## Product Change Notice (PCN)

### LFPCN0011222

#### Product Change Notification for Littelfuse IXLF19N250A

### NEW SHIPPING LABELS

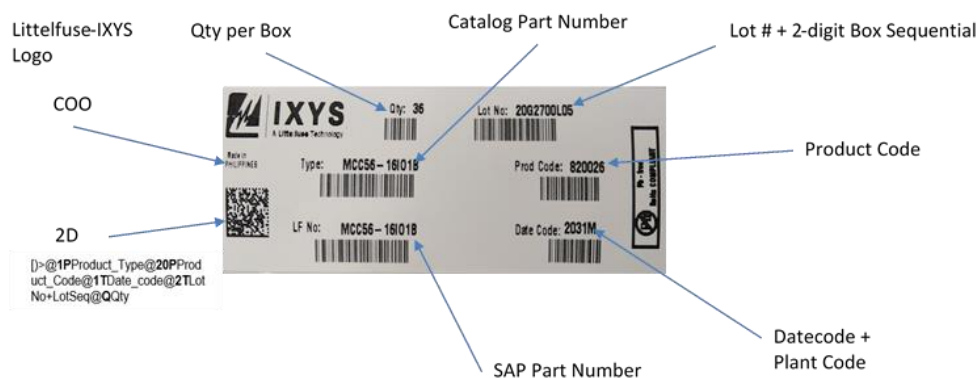
#### Box label

#### Tube label

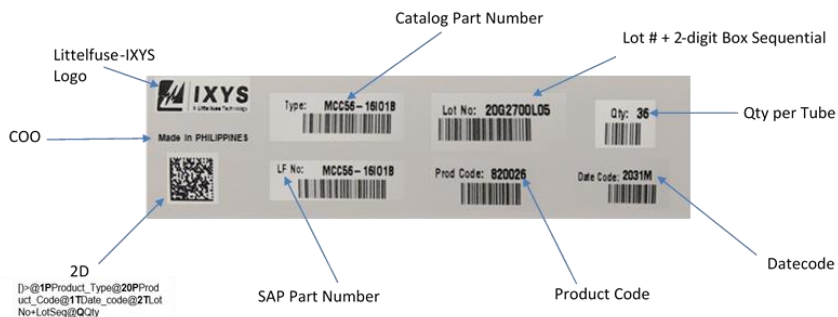
#### RoHS label
